Technical Service Bulletin

SUBJECT:		No: TSB-18-52B-003	
UPDATES TO SRS AIRBAG DIAGNOSTIC TROUBLE CODE PROCEDURES - SERVICE MANUAL REVISION		DATE: December 2018	
		MODEL: 2013-14 i-MiEV	
CIRCULATE TO:	<input type="checkbox"/> GENERAL MANAGER	<input checked="" type="checkbox"/> PARTS MANAGER	<input checked="" type="checkbox"/> TECHNICIAN
<input checked="" type="checkbox"/> SERVICE ADVISOR	<input checked="" type="checkbox"/> SERVICE MANAGER	<input type="checkbox"/> WARRANTY PROCESSOR	<input type="checkbox"/> SALES MANAGER

This TSB updates the Supplemental Restraint System (SRS) section of the affected Service Manuals to provide corrected diagnostic information for front and side impact sensors.

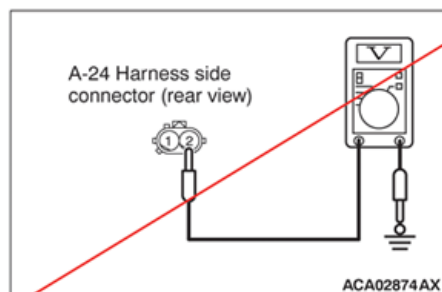
Please make the indicated changes to the 2013 (Canada only) and 2014 i-MiEV Service Manual, Group 52B - Supplemental Restraint System (SRS) -> SRS Air Bag Diagnosis -> Diagnostic Trouble Code Procedures <SRS-ECU>: Replace the Incorrect information with the Correct information for DTC B1407, Diagnosis.

STEP 3. Check the harness wires for open circuit or short circuit between SRS-ECU connector B-113 (terminal No.18 and 28) and front impact sensor (RH) connector A-24 (terminal No.2 and 1).

NOTE: After inspecting intermediate connector B-28 inspect the wiring harness. If the intermediate connector B-28 is damaged, repair or replace it.

NO : Repair the harness wires between SRS-ECU connector B-113 and front impact sensor (RH) connector A-24. Then go to Step 4.

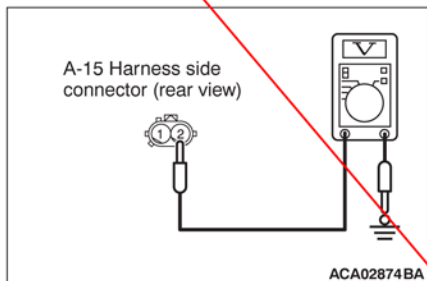
Please make the indicated changes to the 2013 (Canada only) and 2014 i-MiEV Service Manual, Group 52B - Supplemental Restraint System (SRS) -> SRS Air Bag Diagnosis -> Diagnostic Trouble Code Procedures <SRS-ECU>: Replace the Incorrect information with the Correct information for DTC B1417, Diagnosis.

STEP 3. Check the front impact sensor (LH) power supply circuit. Measure the voltage at the front impact sensor (LH) connector A-15.

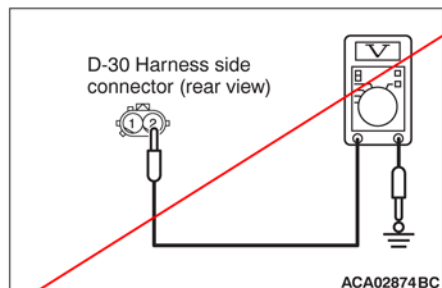
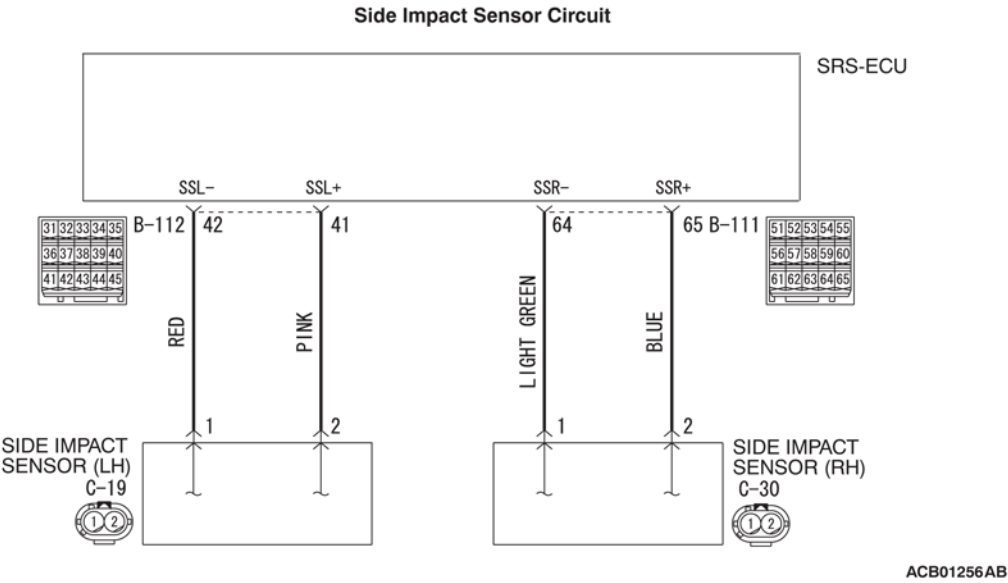
Please make the indicated changes to the 2013 (Canada only) and 2014 i-MiEV Service Manual, Group 52B - Supplemental Restraint System (SRS) -> SRS Air Bag Diagnosis -> Diagnostic Trouble Code Procedures <SRS-ECU>: Replace the Incorrect information with the Correct information for DTC B1427, Diagnosis.

STEP 3. Check the harness wires for open circuit or short circuit between SRS-ECU connector B-111 (terminal No.64 and 65) and side impact sensor (RH) connector C-30 (terminal No.1 and 2).

NO : Repair the harness wires between SRS-ECU connector B-111 and side impact sensor (RH) connector C-30. Then go to Step 4.

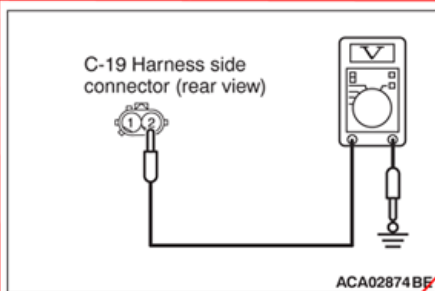
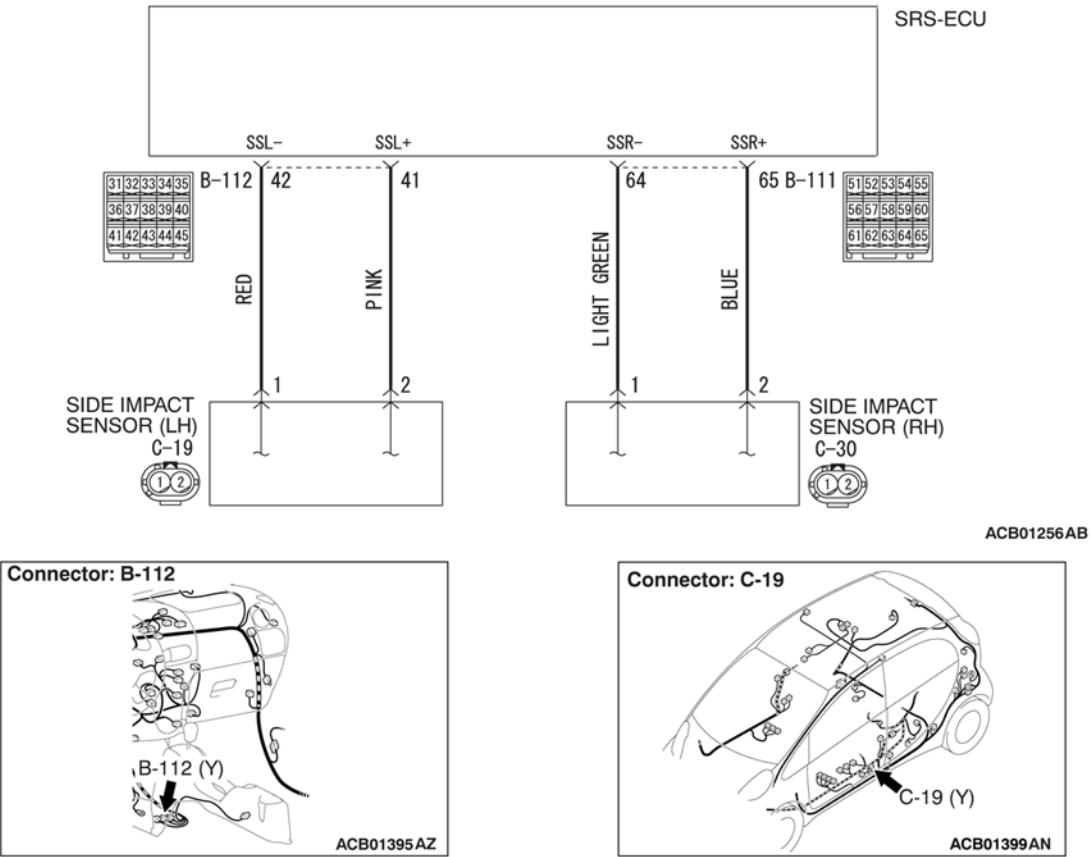
Please make the indicated changes to the 2013 (Canada only) and 2014 i-MiEV Service Manual, Group 52B - Supplemental Restraint System (SRS) -> SRS Air Bag Diagnosis -> Diagnostic Trouble Code Procedures <SRS-ECU>: Replace the Incorrect information with the Correct information for DTC B1437, Diagnosis.

NO : Repair the harness wires between SRS-ECU connector B-112 and side impact sensor (LH) connector C-19. Then go to Step 5.
